Applicant: Ebla Capital, LLC
FLU Category: R-4 and R-9
Service Area: Urban
Site Acreage: 13.41
Community Plan Area: Valrico
Overlay: SR 60 Overlay

AGENCY REVIEW COMMENT SHEET

DATE: 12/02/2021
AGENCY/DEPT: Transportation
PETITION NO: RZ- 21-1341

Unincorporated Hillsborough County Rezoning	
Hearing Date: December 13, 2021 Report Prepared: December 3, 2021	Petition: PD 21-1341 Southwest quadrant of State Road 60 and Mulrennan Road
Summary Data:	
Comprehensive Plan Finding:	CONSISTENT
Adopted Future Land Use:	Residential-4 (0.25 FAR), Residential-9 (0.50 FAR). There is a concurrent Comprehensive Plan Amendment (CPA 21-19) to change the Future Land Use to Residential-20 (0.75 FAR).
Service Area	Urban
Community Plan:	N/A
Requested Zoning:	Residential Single-Family Conventional-6 (RSC-6) and Commercial General (CG) to a Planned Development (PD) to permit 340 multi-family units utilizing the Policy 23.5 Residential Infill Density Bonus.
Parcel Size (Approx.):	13.41 +/- acres (185 565.6 sq. ft.)
Street Functional Classification:	South Mulrennan Road – Collector State Road 60 - Arterial
Locational Criteria	N/A
Evacuation Zone	The subject property is not located in an Evacuation Zone

2.4 Proposed Site Plan (partial provided below for size and orientation purposes. See Section 8.0 for full site plan)

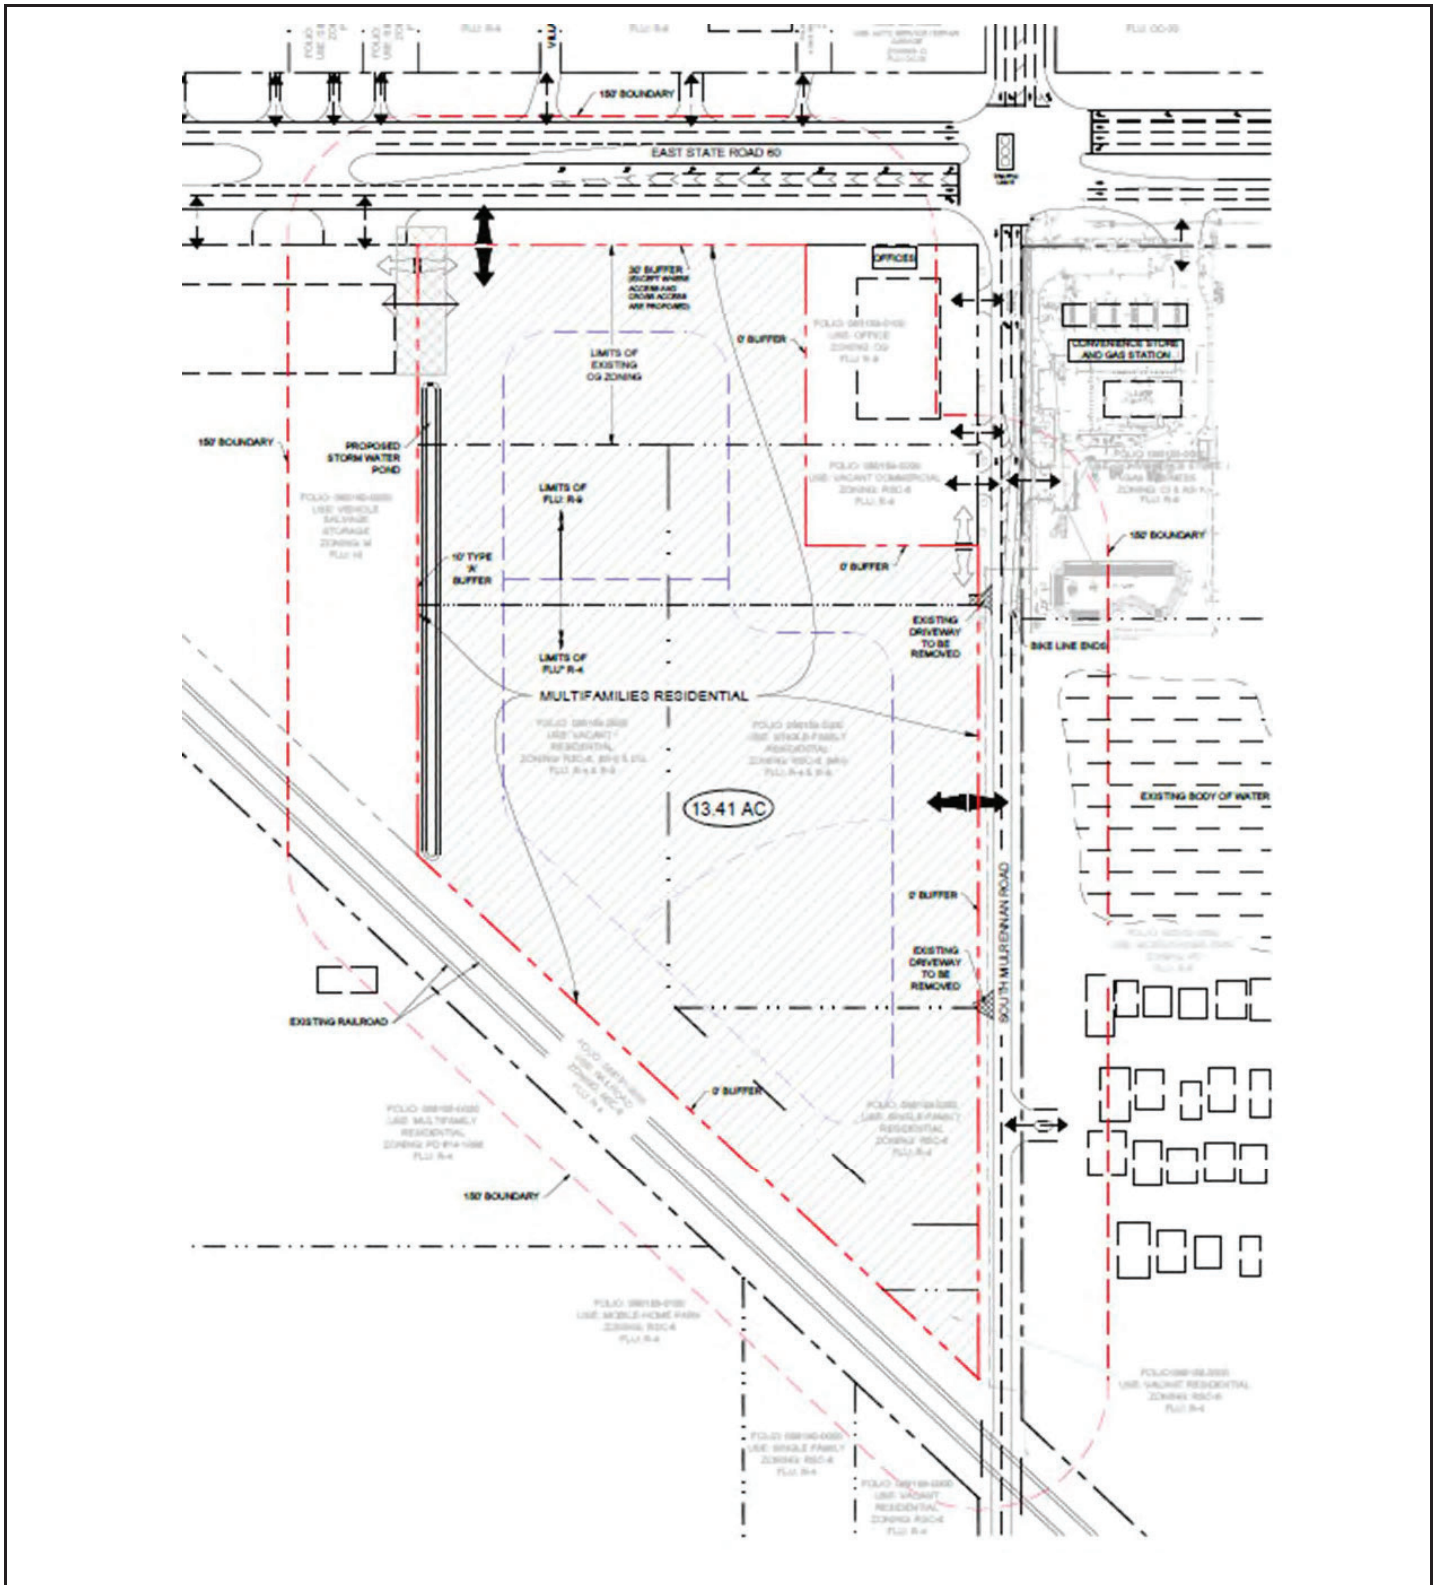
Prior to PD Site Plan Certification, that applicant shall revise the PD General Site Plan to amend side setback requirements to state that the western property line minimum side setback is 20 feet, and all other minimum side setbacks shall be 5 feet.

2. Development of the project shall be limited to 340 multi-family dwelling units.
3. Building setbacks shall be as follows:
 - Front: 20 feet
 - Rear: 10 feet

- Sides: the western side setback shall be 20 feet, and all other side setbacks shall be 5 feet.
4. The maximum building heights shall be 60 feet. The additional setback of 2 feet for every 1 foot over 20 feet in height shall not apply.

FIGURE 2. PROPOSED TYPICAL SECTIONS

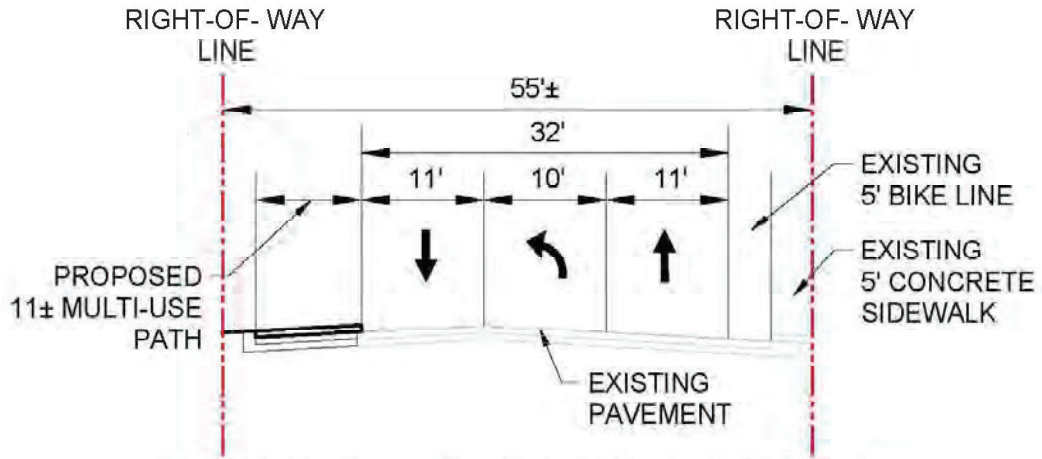
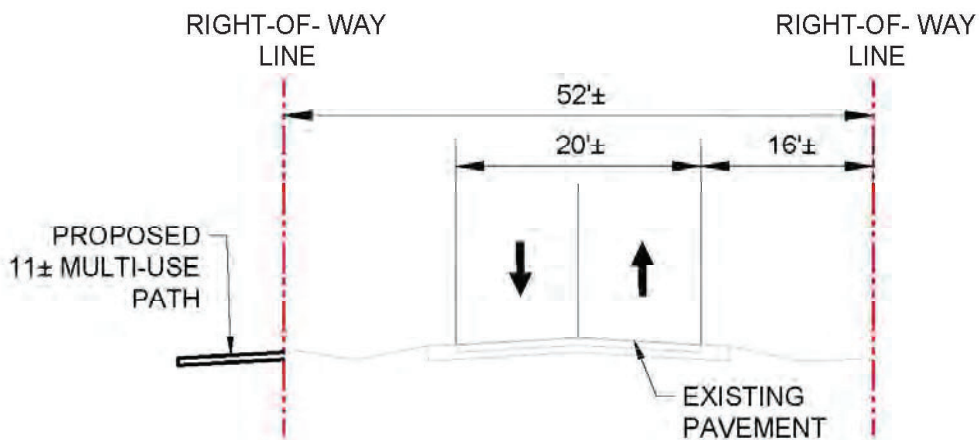
1. The existing ROW along Mulrennan Road is approximately 55 feet. The typical TS-4 section for an urban, two-lane undivided roadway requires a minimum of 74 feet (additional 10 feet for the left turn lane) of ROW with 11-foot lanes, 7-foot buffered bike lane, 5-foot sidewalk, 5-foot grass strip and F type curb.
2. The request is to maintain the 11-foot travel lanes, 10-foot left turn lane, 5-foot bike lane on the east side and a 5-foot sidewalk on the east side. However, on the west side of Mulrennan Road, the F type curb will be added and an 11-foot multi-use path will be added to the back of curb in lieu of the buffered bike lane, sod strip and 5-foot sidewalk. This will potentially require removal of several existing oak trees within the right of way.

2. The request is to provide 10-foot lanes instead of 12-foot. Based on Table 3-20 of the Florida Green Book, the 10-foot travel lanes and turn lanes are identified as acceptable. In addition, on the west side, an 11-foot multi-use path is proposed to be provided in lieu of the bike lane and sidewalk. Due to ROW constraints and the existing tree canopy along the west side, the multi-use path will be placed outside of the current right of way. No modifications to the east side of Mulrennan Road will be made due to the limited right of way.

- If PD 21-1341 is approved, the County Engineer will approve a Design Exception (dated October 25, 2021) which was found approvable by the County Engineer (on December 2, 2021). Approval of this Design Exception will allow construction of a multi-use trail within and adjacent to Mulrennan Rd. right-of-way in lieu of the standard TS-4 and TS-7 typical sections, respectively, of the Hillsborough County Transportation County Technical Manual required by Section 6.02.07. of the LDC. The specific improvements shall include:

- Multi-Use Trail Segment A: The developer will construct within the right-of-way on the west side of Mulrennan Road, from SR 60 to approximately 500 feet south, an F type curb with an 11-foot multi-use path to the back of curb in lieu of the buffered bike lane, sod strip and 5- foot sidewalk required by the standard TS-4 typical section.

- Multi-Use Trail Segment B: The developer will construct adjacent to the west side of Mulrennan Road, from the terminus of Trail Segment A south to CSX right-of-way (+/- 800 feet), an 11-foot multi-use path in lieu of a 5-foot sidewalk and paved shoulder required by the standard TS-7 typical section. At time of construction permitting, an easement agreement or right of way dedication, whichever is acceptable to the County, will be made to convey public rights to the multi-use path.

FIGURE 3. PROPOSED ROADWAY MODIFICATIONS

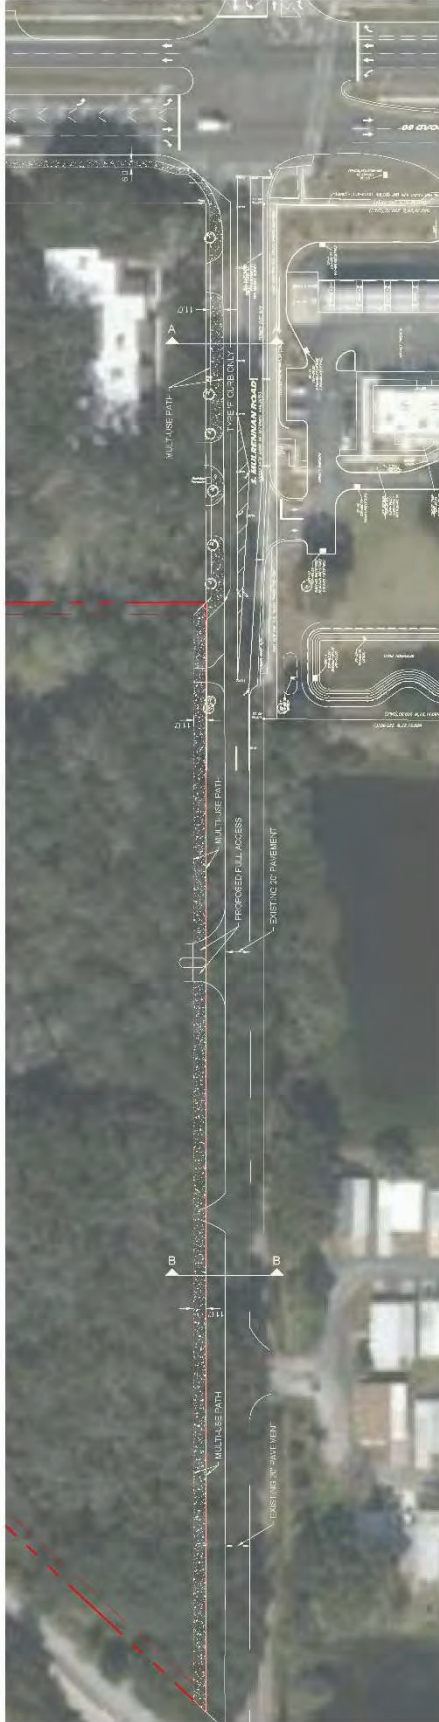
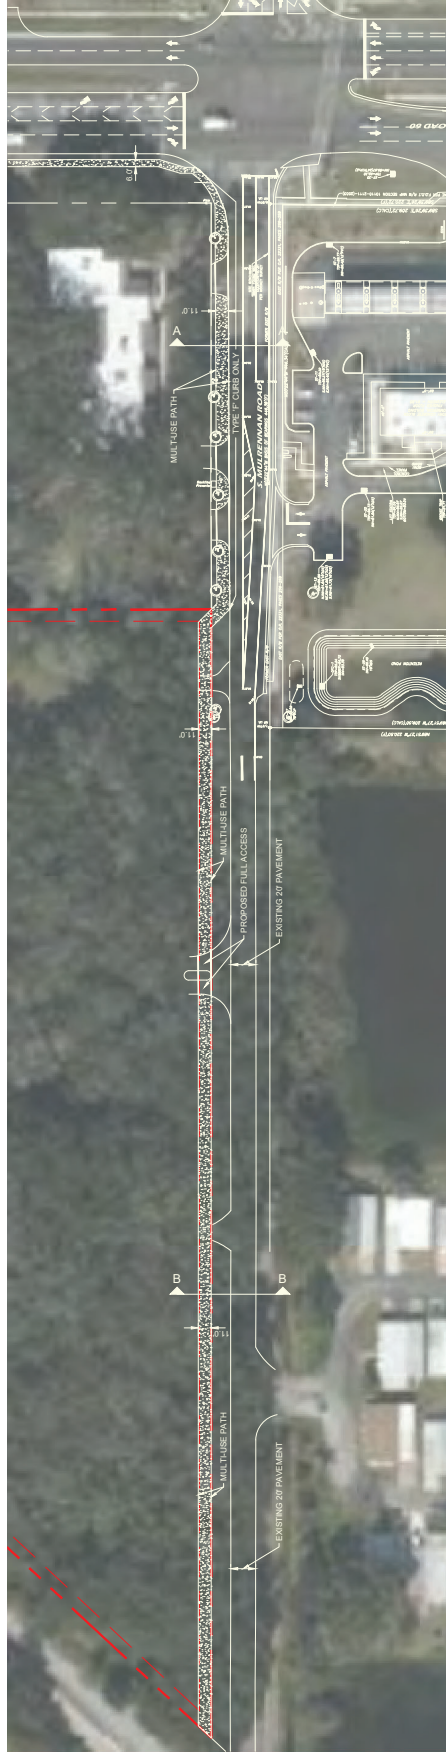
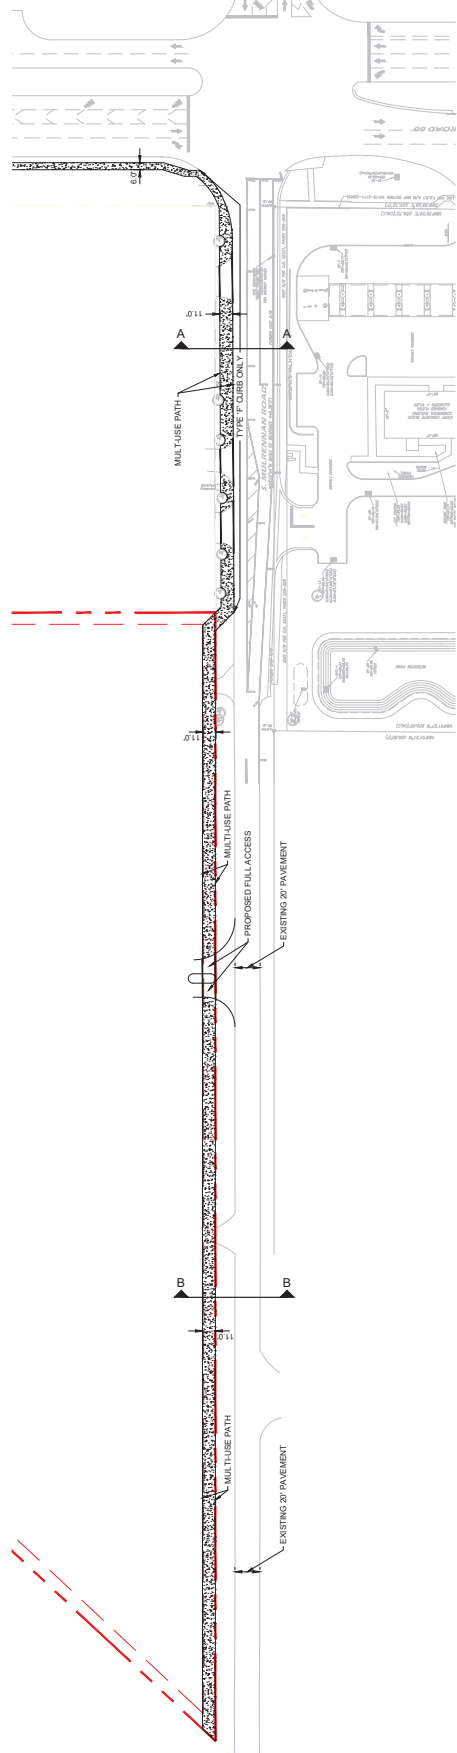
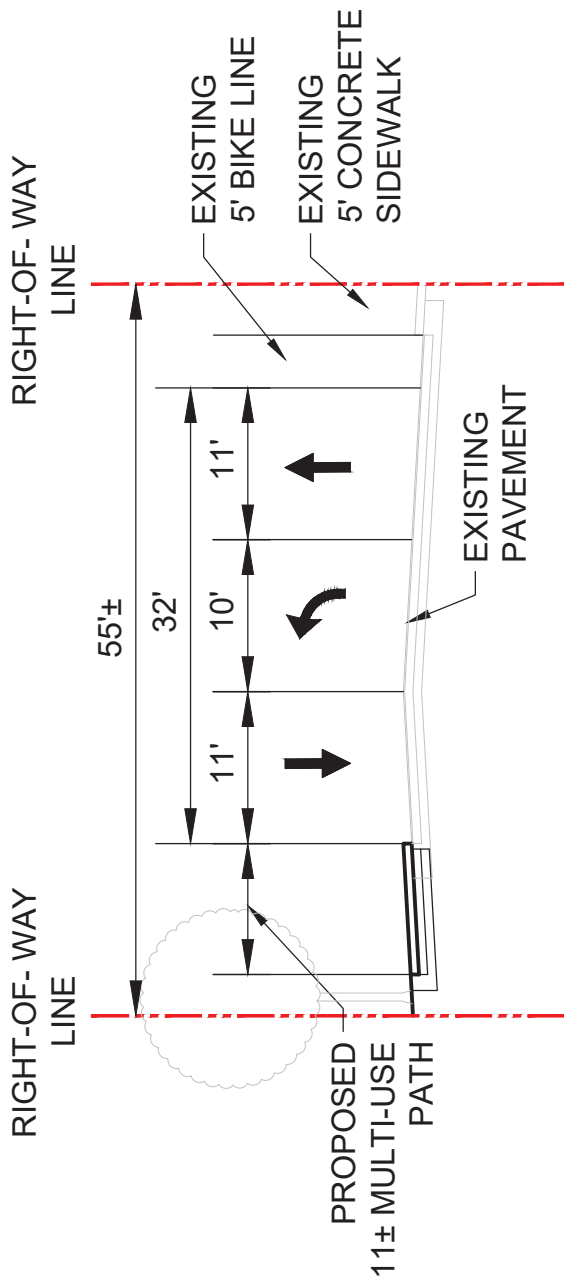
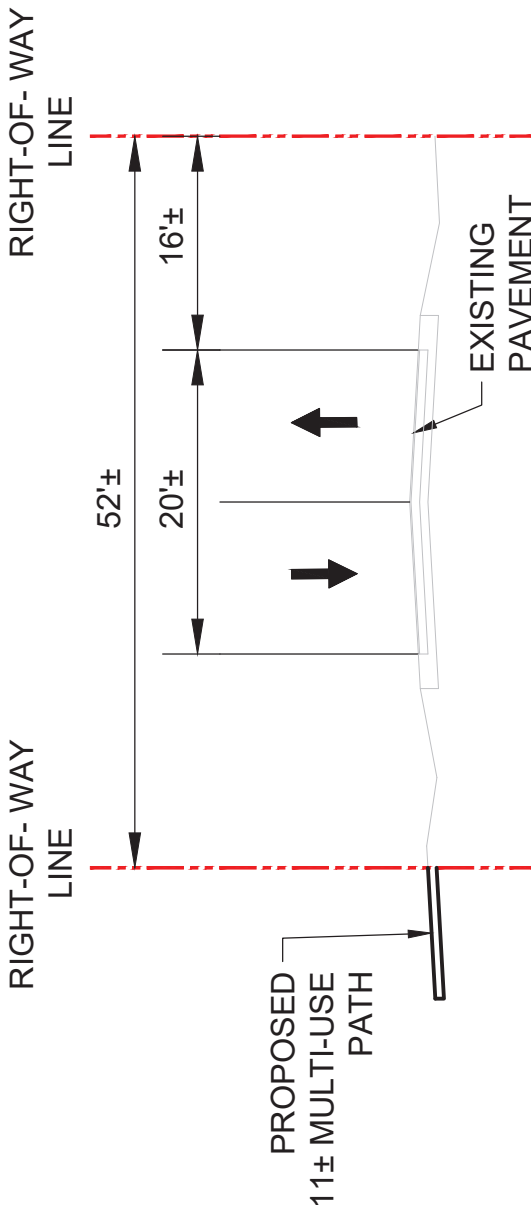
1. Multi-Use Trail Segment A: The developer will construct within the right-of-way on the west side of Mulrennan Road, from SR 60 to approximately 450 feet south, an F type curb with an 11-foot multi-use path to the back of curb in lieu of the buffered bike lane, sod strip and 5- foot sidewalk.
2. Multi-Use Trail Segment B: The developer will construct adjacent to the west side of Mulrennan Road along the project's eastern boundary, from the terminus of Trail Segment A south to CSX right-of-way (+/- 800 feet), an 11-foot multi-use path in lieu of a 5- foot sidewalk and on-street bike lane.

The proposed typical section is shown in Figure 2 and the proposed improvements are shown in Figure 3.

Segment B is not within the existing right-of-way, therefore staff is recommending that at time of construction permitting, an easement agreement or right of way dedication will be made to convey public rights to the multi-use path.

If this zoning is approved, the County Engineer will approve the Design Exception request.
